**FILE:** STP00-0151-01(005) Murray **OFFICE:** Engineering Services  
P.I. No.: 631550  
SR 225/Spring Place Bypass **DATE:** April 22, 2010

**SUBJECT: IMPLEMENTATION OF VALUE ENGINEERING STUDY ALTERNATIVES**

**SUBJECT** VE Study Responses

**Office of Roadway Design's Responses to the VE Study Report on  
GDOT project STP00-0151-01(005) Murray County  
PI No. 631550**

**Description:** Combine two bridges to one bridge with positive separation

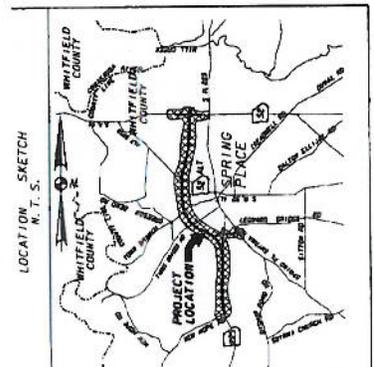
**Alternative BR-3**

**Cost Savings:** \$649,836

**Response:** With the proposed implementation of VE alternative R-12, this alternate was no longer considered. The bridge width will be revised to accommodate a typical rural 2 lane roadway with two 12 foot lanes and 10 foot shoulders. Cost Estimate for single bridge is \$ 1,260,000.00.

**The recommendation of the Roadway/Bridge Design Office is:** No, due to implementation of RD 12.
